RS-03-133

> Dresden Nuclear Power Station, Units 2 and 3 Facility Operating License Nos. DPR-19 and DPR-25 NRC Docket Nos. 50-237 and 50-249

Response to Request for Additional Information – License Renewal Environmental Report for Dresden Nuclear Power Station, Units 2 and 3

Attachment 1: RAI Responses Related to Severe Accident Mitigation Alternatives

Figure 3-1
Typical Dresden Level 2 Containment Event Tree

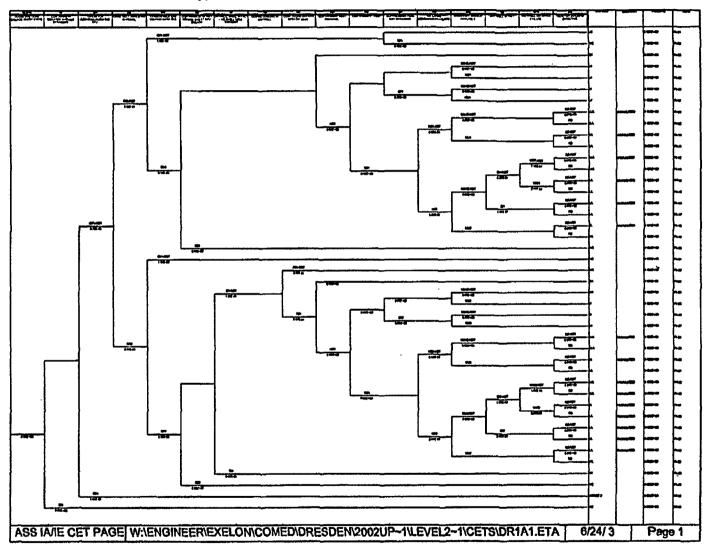
"[Provide] each release (consequence) category used in the Level 3 analysis (as listed in Column 1 of Table 4-5), the specific source terms used to represent each release category, and a containment matrix describing the mapping of Level 1 results (plant damage state frequencies) into the various release categories."

The CET calculation for each cutset uses Boolean logic and fault tree models to process the incoming Level 1 cutsets to ensure that the resulting Radionuclide release frequencies properly reflect the impact on release magnitude and timing of the containment and containment mitigation systems. A typical CET (for Accident Class 1A) is provided in Figure 3-1.

In summary, the Level 1 end states do not translate directly into release categories. Each Level 1 accident sequence (all of the cutsets) is transferred into the appropriate CET. The CET is then used to determine the resulting frequency for each radionuclide release end state from each incoming cutset. This is typical of a full Level 2 for a binned fault tree model. This approach does not involve a matrix that relates Level 1 sequences directly to Radionuclide end states.
